January 31, 2014  
L-2014- 023

Re: Turkey Point Units 3 and 4  
Docket Nos. 50-250 and 50-251  
Response to NRC Request for Information Pursuant to 10 CFR 50.54(f) Regarding the Flood Hazard Reevaluation Report (FHRR), Recommendation 2.1 –Flooding

**Response to NRC Request for Information Pursuant to 10 CFR 50.54(f)**

**Regarding the Flood Hazard Reevaluation Report (FHRR)**

Figure 7- 1 General Model Layout

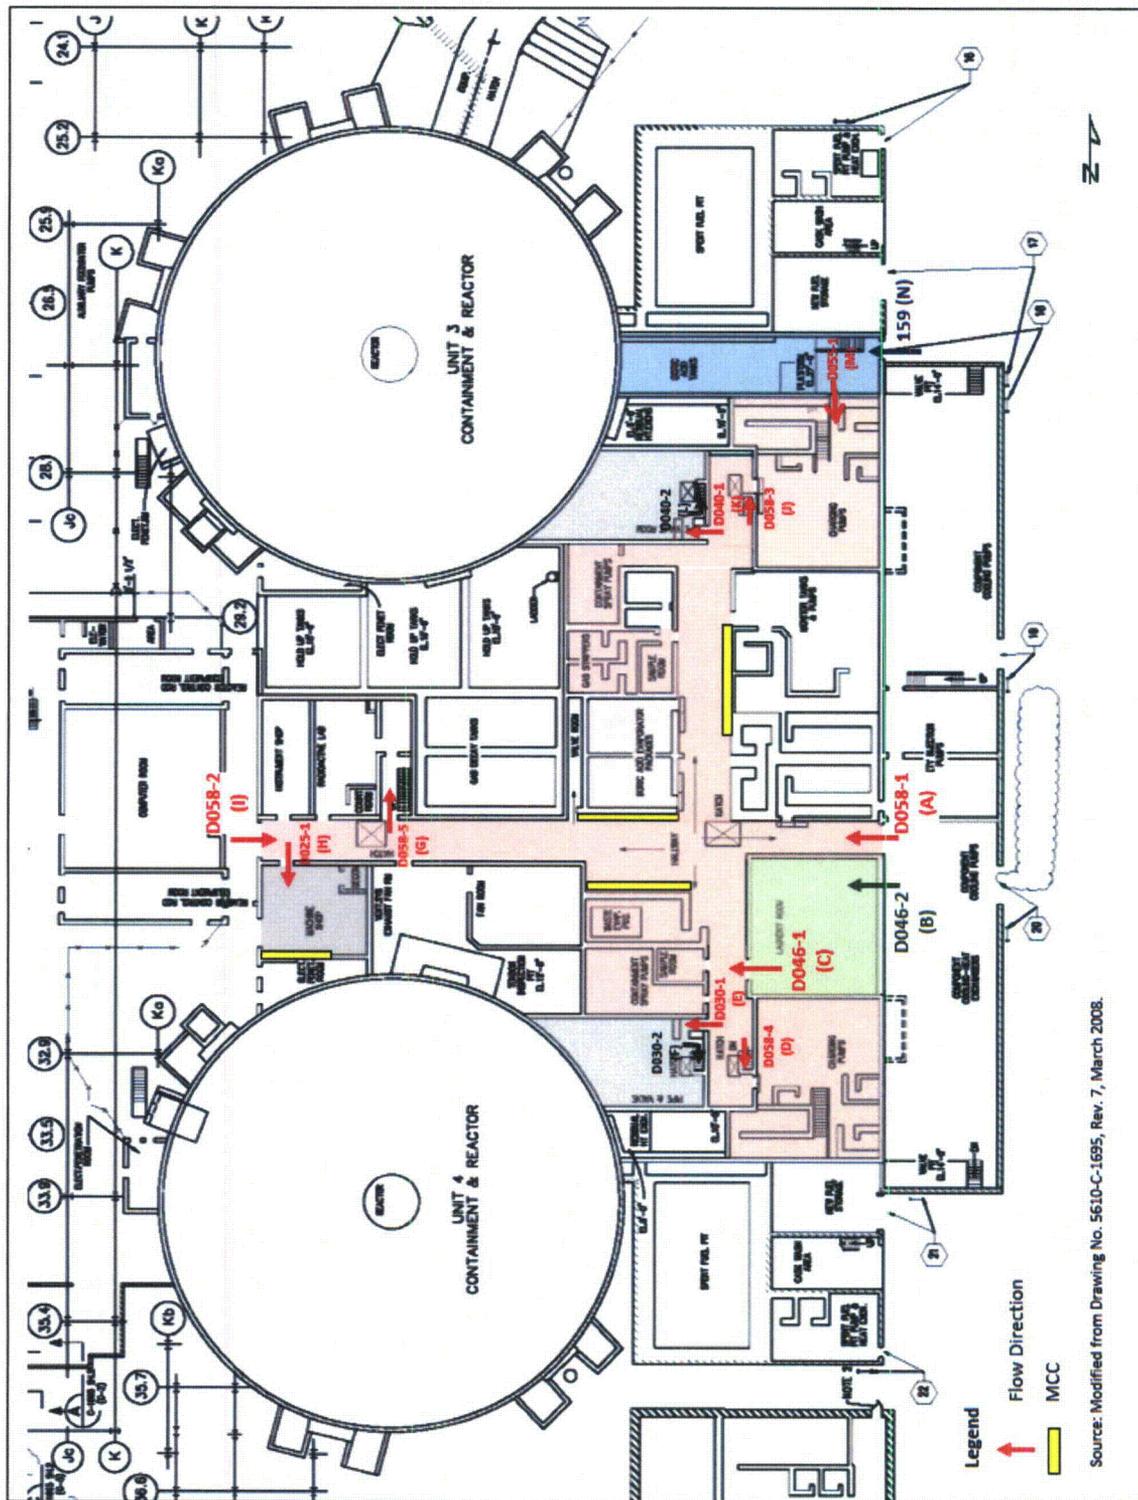
The discussion provided in the FHRR for local intense precipitation (LIP) Scenario A, presented on page 71 indicates that flood water could enter the non-watertight east doors of the Auxiliary Building and that there are three motor control centers (MCCs) “several feet” west of the doors. The FHRR states that these MCCs would not be affected by flooding because they are mounted on curbs that elevate them 5 inches above the floor and because water would flow down to lower levels of the building. Since the qualitative description does not explain the volume of water coming through the depth of accumulation inside the room, the NRC staff requests the licensee to provide quantitative information in support of this conclusion.”

A more detailed analysis for this area was planned for the integrated assessment. To provide the response to this RAI, the work was accelerated in order to provide a quantitative estimate of possible flows into the building under the LIP conditions, the water levels inside the building, and the corresponding water volumes of water involved in surrounding areas of the MCCs. A flow model was developed which simulates the accumulation of water inside the Auxiliary Building from exterior unsealed doors, and outflow through unsealed closed doors to the lower levels of the building. The model treats the inside of the building as a reservoir and the points of inflow and outflow as orifices. Inflows at each potential entry point (unsealed doors) are modeled using the water-depth hydrographs produced in the FLO-2D LIP model. Each of the simulated LIP distributions (described in RAI 1 response) is analyzed to determine the worst-case scenario. Areas of the Auxiliary Building with normally open doors are modeled as a connected volume to the hallway with the exception of the Monitor tank room which was excluded for conservatism. Figure 7-1 shows shaded areas where water is assumed to flow once entering from exterior doors.

There are four potential points of inflow from the exterior of the building that can reach the central hallway: D058-1, D058-2, D046-2, and 159. D058-1, D046-2, and 159 are located on the east side of the Auxiliary Building, and D058-2 is located on the west side (See Figure 7-1). Note that inflow through door D046-2 enters the Laundry Room and then must go out through door D046-01 to reach the interior of the building; inflow through door 159 reaches the interior of the main hallway through door D055-1; this process is simulated in the model. The model also simulates flow into the Electrical Equipment Room through door D025-1.

Water that accumulates inside of the building can flow out through gaps in closed doors to the lower levels of the Auxiliary Building. There are 6 direct-route outflow points (unsealed doors) from the center hallway: Doors D058-4, D030-1, D058-5, D025-1, D058-3, and D040-1. Doors D030-1 and D040-1 provide access to Doors D030-2 and D040-2, respectively, to stairwells to lower levels. The model configuration is presented in Figure 7-1.

The maximum water level in the main hallway was determined to be 4.7 inches above the floor. As stated in the FHR, the MCC are mounted on concrete pads which elevate them 5 inches off the floor. This includes structural support steel that is part of the MCC frame.

The total integrated volume of water entering each of the four RHR pump rooms or the Waste Holdup Tank area over the 1 hour LIP is approximately 330 ft<sup>3</sup>. Using the smallest room, a maximum flood height of 1.4 feet would be reached. The critical height for RHR equipment located in the pump room is greater than 3 feet off the room floor. Furthermore, each RHR pump room has two 75 gpm (10 cfm) sump pumps powered from redundant safety trains. The 20 cfm pumping capacity exceeds the maximum flooding inflow of approximately 6 cfm to the room. Therefore, buildup of water in the room is not expected. There is no safety related equipment in the Waste Holdup Tank area or connecting hallway on the 2 ft elevation of the Auxiliary Building hallway.
